## **Attachment No. PC 3**

Staff Responses to Appeal

## **Staff Responses to Appeal**

*Figure 1: Westerly View from Ocean Boulevard*

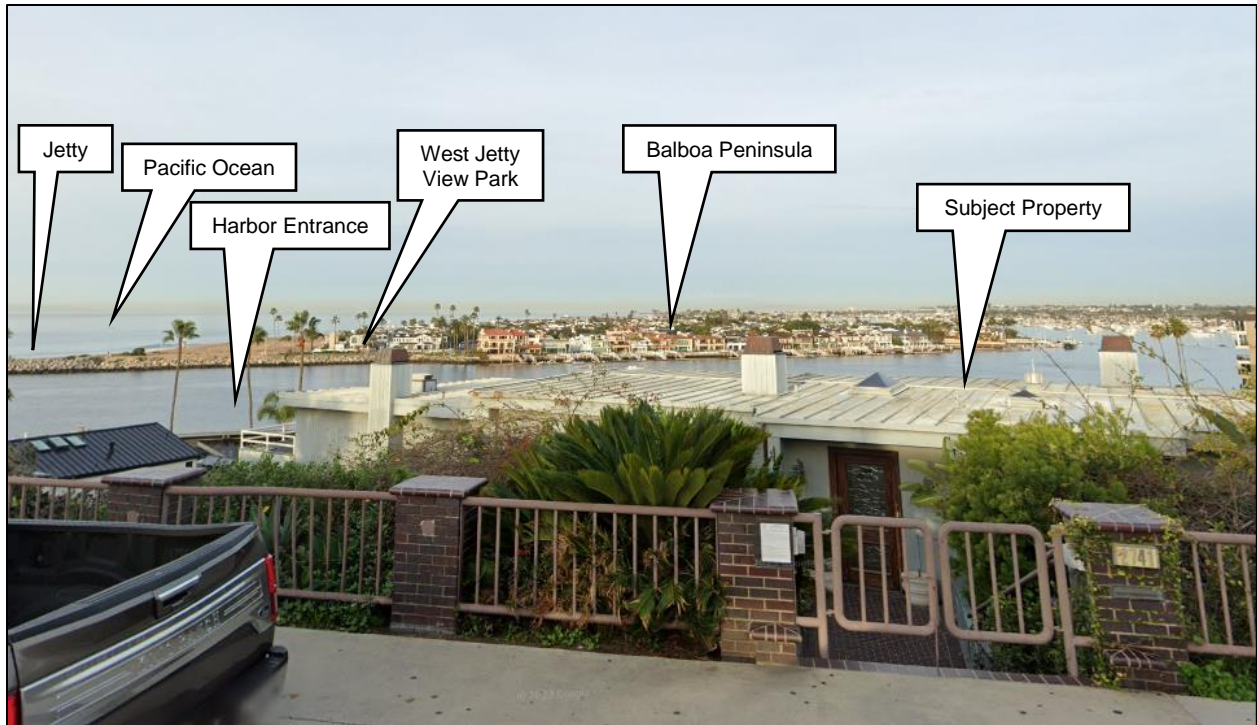
*CLUP Policy 2.2.5-1 states, in relevant part, that "Legal nonconforming structures shall be brought into conformity in an equitable, reasonable, and timely manner as rebuilding occurs. Limited renovations that improve the physical quality and character of the buildings may be allowed." The proposed 2,511 square feet, or more, addition of office, entryways and more, all visible from Ocean Boulevard, goes well beyond what is needed to achieve the applicant's stated intent "to provide interior access to all residential levels." Although Policy 2.2.5-1 is not mentioned in the resolution, Fact L.5 cites the provision of NBMC Subsection 21.38.040(G), which goes even further by allowing additions only to a nonconforming structure that "does not block or impair public views to and along the sea or shoreline or to coastal bluffs and other scenic coastal areas." In this case the existing non-conforming structures most definitely blocks views of the harbor from Ocean Boulevard, as well as views to the bluff from the harbor. It would, therefore, appear to be ineligible for additions."*

As addressed by Fact 5.a in support of Finding L in the draft resolution, the project is consistent with Policy 2.2.5-1 (Nonconforming Structures and Uses). The existing residence was authorized by Variance No. 1137 and includes portions of the roof which exceed the Ocean Boulevard curb height. However, there is an expansive view of the harbor and ocean for motorists and pedestrians on Ocean Boulevard, and the existing residence does not block the view nor significantly impair it. When viewing west from Ocean Boulevard, there are existing views of the harbor, harbor entrance, Pacific Ocean, the jetty, West Jetty View Park, the Balboa Peninsula, and beyond (See Figure 1, below).
